2017 Upgrade

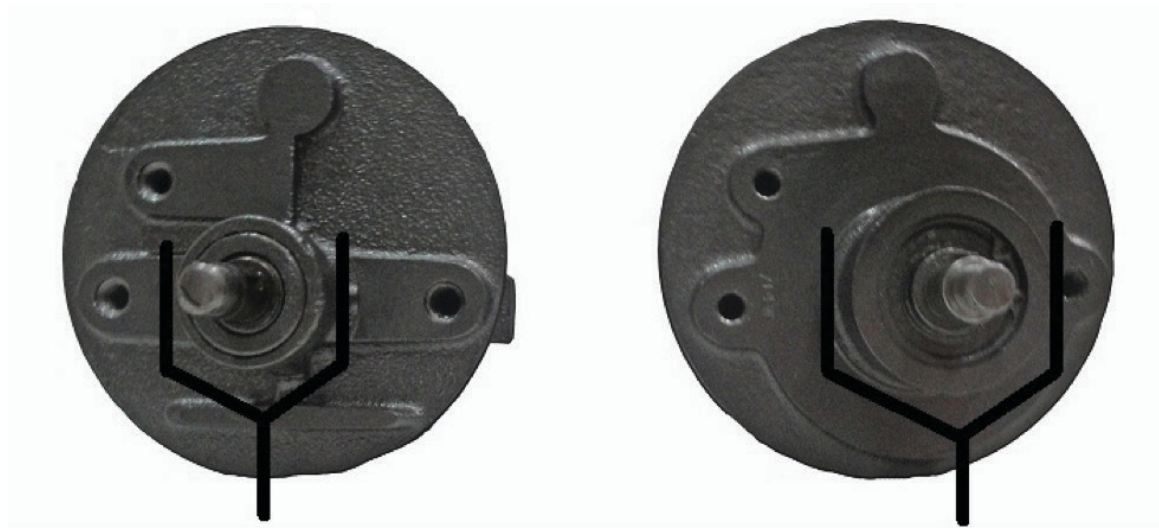
This power steering pump has been improved over the original bushing design to a bearing style. You may need to remove some material from your mounting bracket to insure you have at least 1/8" clearance between the pump body and the bracket.

**Bushing Style
Housing Diameter 1.60"**

**Improved Bearing Style
Housing Diameter 1.91"**
